Access Compliance Report

(Curb Ramps)

Intersection ID: 49292	Main Street: ROYAL_WINCHESTER_DR	Cross Street: CHAMBERLIN_RD	Location: S
ADA ID: 542335A2D37A	Ramp Type: PerpDiag	Initial Pass/Fail: Pass	Overall Compliance: No
Severity Score: 7.5			
Codes/Mitigation Info/Possible Solution		Field Measurements/Component Compliance

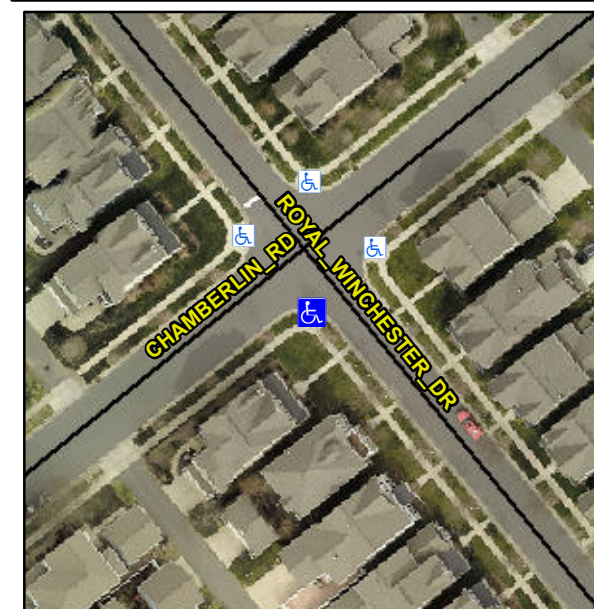
R304.2.1, R304.2.2-Perp, R304.3.2-Para, R305.2, R302.7.2

Remove & Replace Curb Ramp With Two New Directional Ramps or Equivalent. Grind Gutter Lip.
